Subject
2003 Duramax Addendum

Application
C20066/C20066AT
Exhaust Brake

Fig 1.

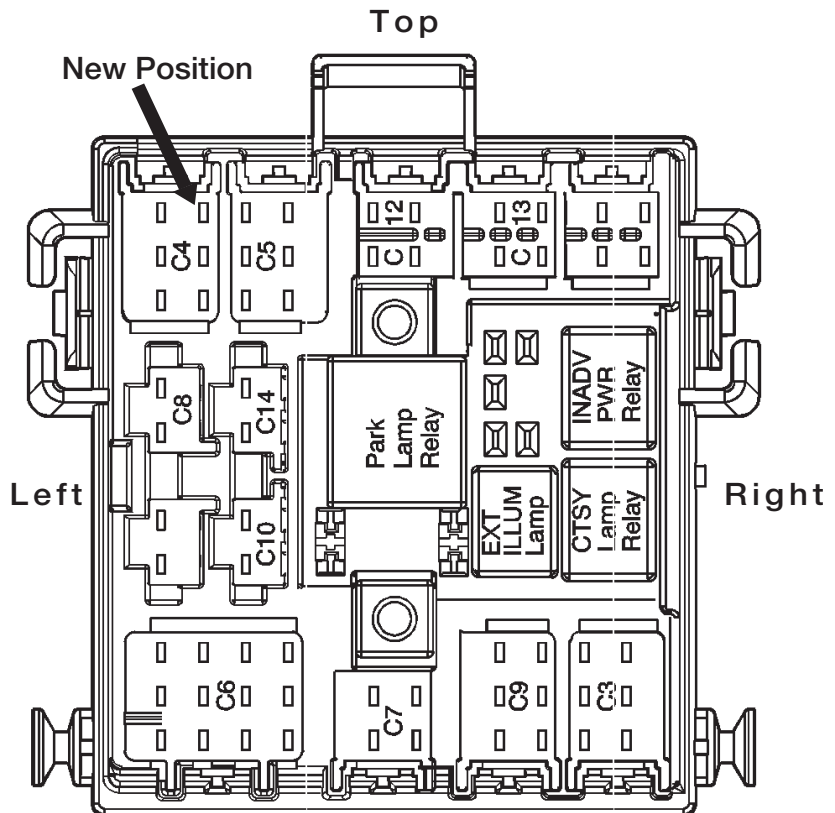
- 1 The MIDBEC connector shown in step 16 of the installation manual has changed. Please tie into the connector indicated in Fig. 1 instead.
- 2 The cruise control activation line tapped in step 11 of the installation manual has changed. Where you used to connect to a metri-pac connector beside the steering column, there is now a cam-lock connector. Please tap the gray/white wire at position B32 as shown in Fig 2.
